**Appendix F Geomorphology memo on channel
widening/berm lowering**

To:	Francie Morrow, GWRC	Job No:	1093438.0000
From:	Ian Fuller	Date:	7 March 2025
cc:	Mark Hooker		
Subject:	Waipoua Geomorphic Advice

This memo provides a high level, qualitative assessment of possible geomorphic responses in the Waipoua River through Masterton to:

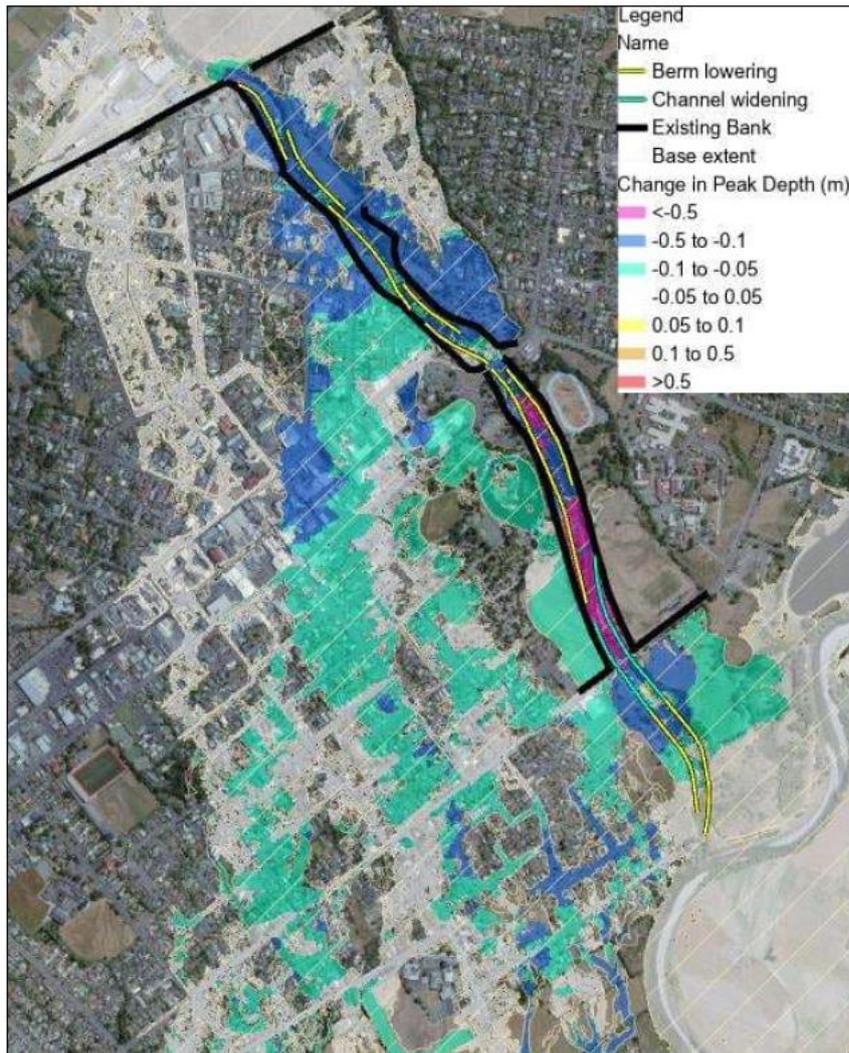
The geomorphic effects of berm lowering, and channel widening are related to the energy of flows in the channel and the substrate lining the bed and banks. Changes to the cross-sectional form of the river as a result of berm lowering and widening of the cross-sections (Figure 1.1) will result in lowered flow depths (Figure 1.3) because the enlarged channel has an increased capacity to convey flows. In turn this means that more water is retained within the Waipoua channel, rather than spilling out onto the adjacent berms. In this scenario, water is conveyed very efficiently since channel boundary resistance is reduced as wetted perimeter is reduced. The energy of these flows will increase as a result of this greater flow efficiency because less energy is dissipated by roughness effects.

Widening under the Colombo Road bridge will improve flood capacity but potentially require structural intervention to preserve the integrity of bridge piers should the bed of the river degrade further. Widening does not appear to have a significant impact on velocities, which remain high or slightly higher following the increased channel capacity at these cross-sections (Figure 1.1).

Widening of the channel in XS 1-3 (Colombo Road bridge) does provide the potential for some development of bar forms in the channel. Widening provides accommodation space for bars to form, and deposition of gravel may be encouraged. Similar effects have been observed in the Waikanae River in the vicinity of Jim Cooke Memorial Park, where channel widening has been permitted, contributing to bar-form development and an increased diversity in geomorphic units (riffles, lateral bars, medial bars) at low flow (Figure 1.6). Should widening of the Waipoua bed be extended beyond

(upstream) of Colombo Road bridge, similar effects would be anticipated. However, lowering of the berms alone does not increase accommodation space in the channel at low flows, because the bed is not being widened in what is proposed. This means that the changes proposed in XS 4-8 would not facilitate in-channel deposition of bedload, which might be expected in a widened bed. Berm lowering itself will be not improve geomorphic diversity in the channel.

Figure 1.2: Depth difference layer for a 1% AEP flow (Q_{100}) between the base scenario and LRS combined option 13 (channel widened and berms lowered), source: Land River Sea Consulting Limited Memorandum to Greater Wellington Regional Council, 13 September 2024, Figure 2-22

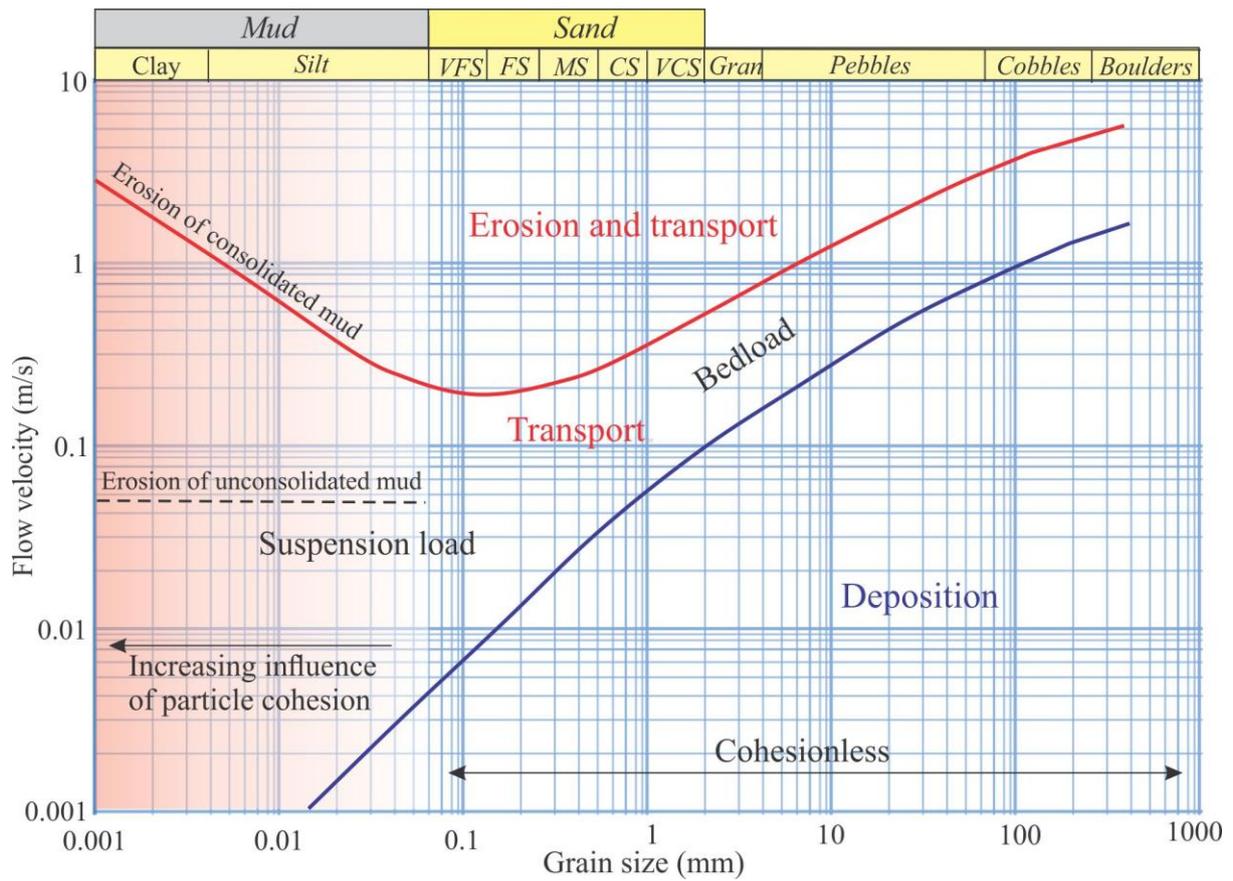
Modelled results indicate that while Q_{100} flood depths are reduced by berm lowering, in-channel velocities increase in all sections. Using the Hjulström curve as a means of estimating critical velocities of entrainment, the modelled velocities in a Q_{100} flood exceed those required for entrainment of boulders (Figure 1.3).

Figure 1.5: Proposed high-flow channel (pink outline) upstream of Mawley Park, to connect with small true left bank tributary (blue line)

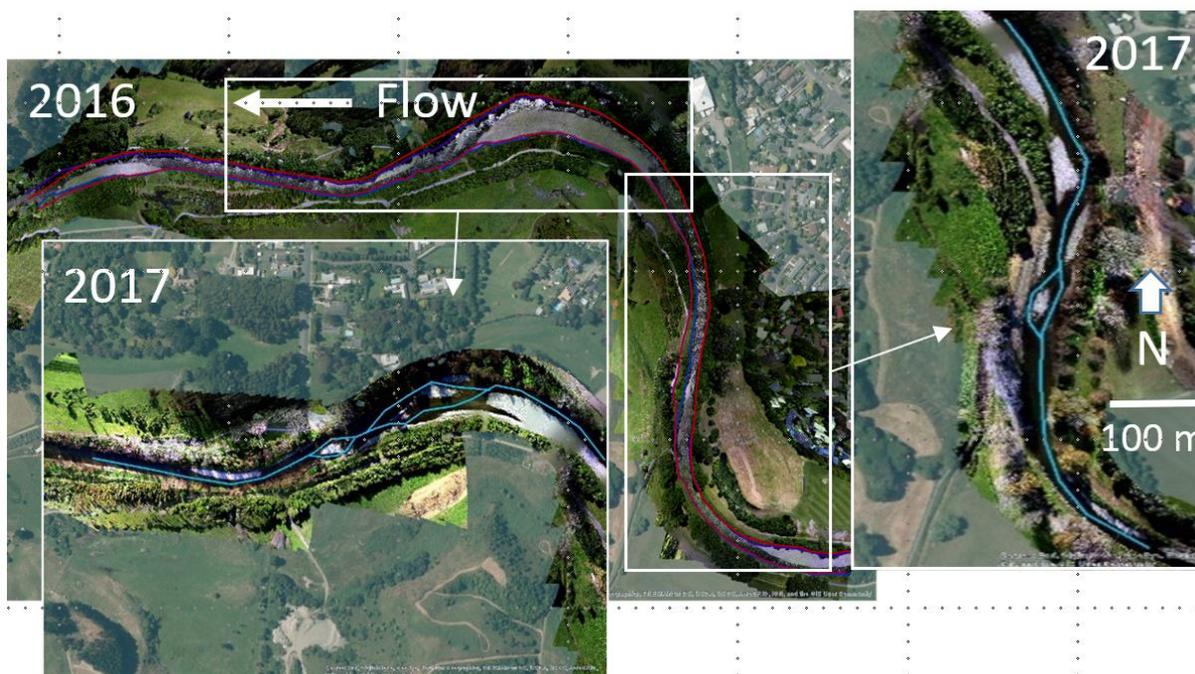
A high-flow path upstream of Mawley Park (Figure 1.5) is proposed to be activated during large floods (only), with a view to developing a wetland in this area. Reactivating floodplain in this way would contribute to some energy dissipation, although the area is small and realistically unlikely to have a significant influence on conditions in the channel. There may be benefits in allowing re-engagement during smaller floods and from a habitat diversity perspective.

A planned high-flow channel upstream of Mawley Park could be subject to re-sedimentation in the same way as lowered berms. In essence this is a natural process: abandoned channels and wetlands on the floodplain will fill up over time.
